**TOWN OF CARMEL**  
**PLANNING BOARD**

**PLANNING BOARD AGENDA**  
**MARCH 9, 2023– 7:00 P.M.**

RE: 1035 Rt 6 – Platinum Propane  
Town of Carmel  
TM# 65.10-2-11

Re: Comment Response Letter for Proposed Boutique Hotel at  
910 South Lake Blvd, Town of Carmel, NY

DRAWING: NYSDOT ENTRANCE PLAN

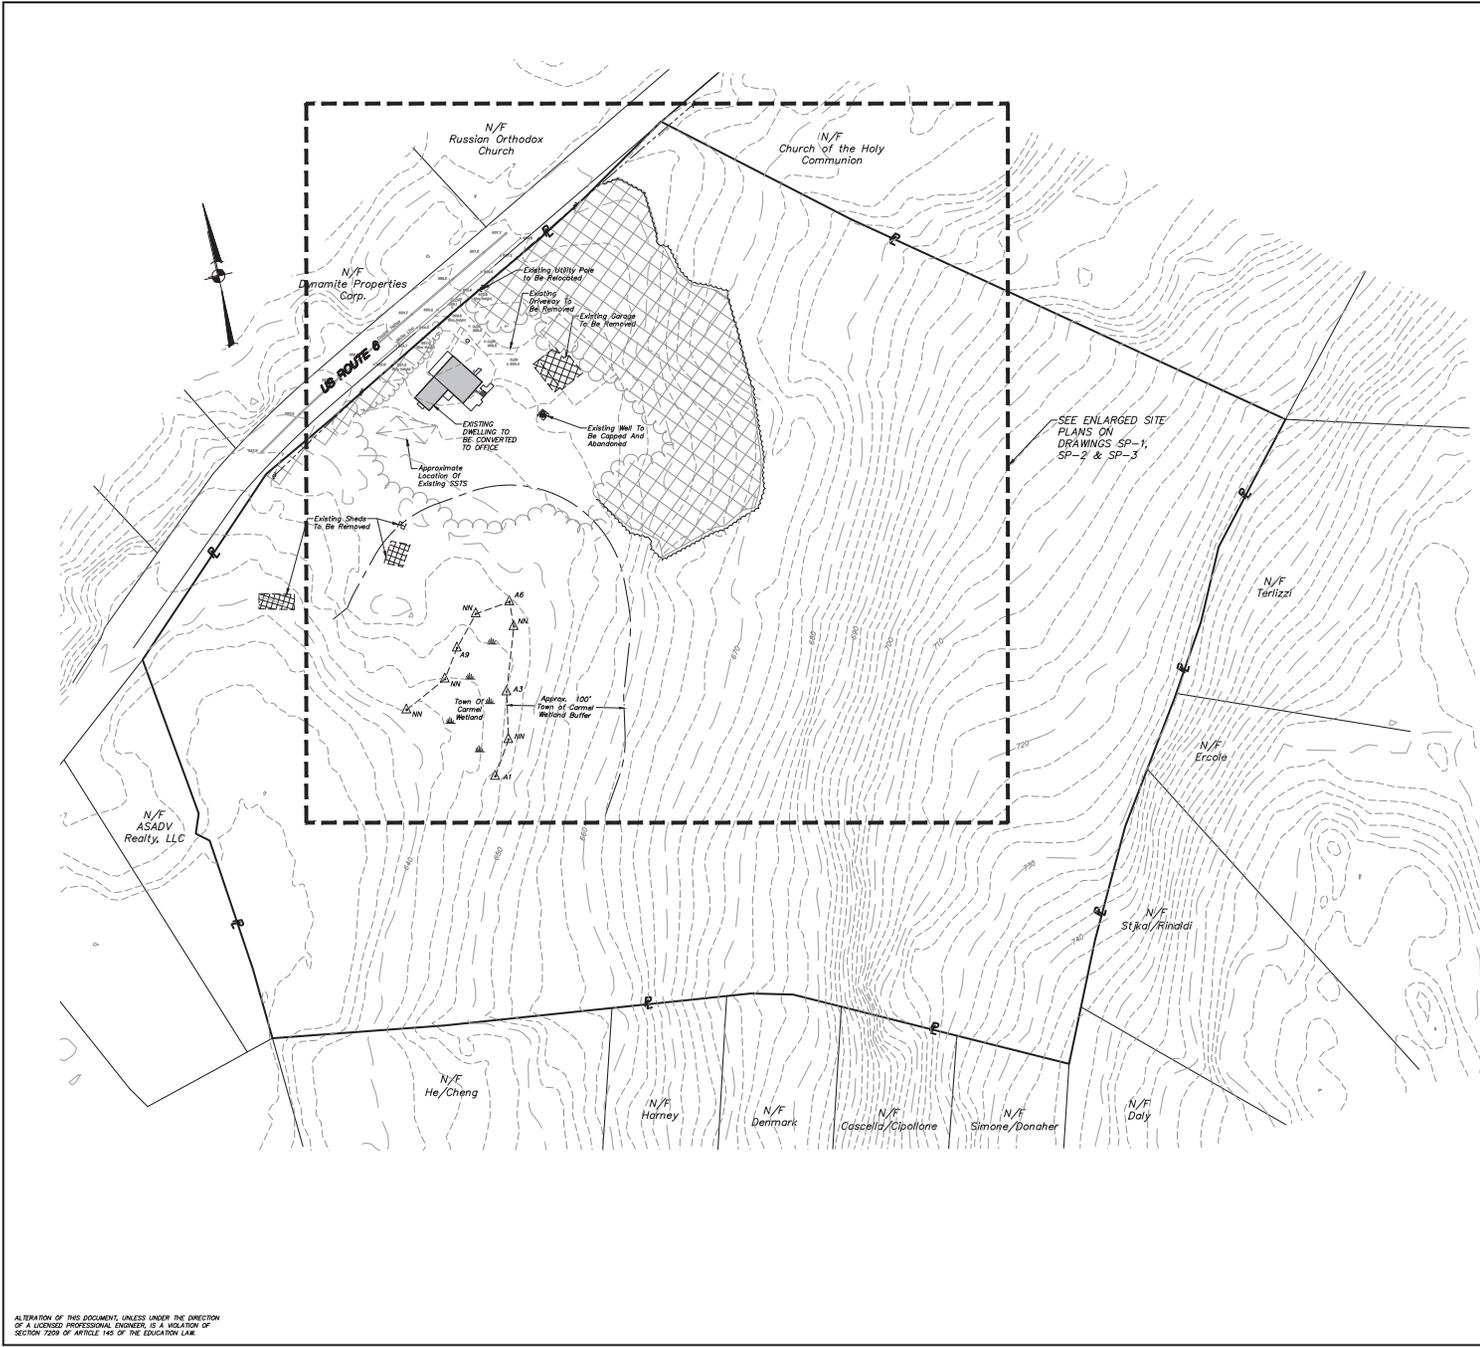
4. Traffic and vehicle movements are shown on drawing D-1.
  - a. This comment is acknowledged.
  - b. See the enclosed NYSDOT Entrance Plan.
  - c. Driveway slopes at the entrance are indicated on drawing SP-2, and on the enclosed NYSDOT Entrance Plan.
  - d. The applicant would prefer not to perform a traffic study at this time as the project does not exceed the thresholds defining the proposed improvements as causing a "significant increase" in traffic under the guideline provided in the Environmental Assessment Form
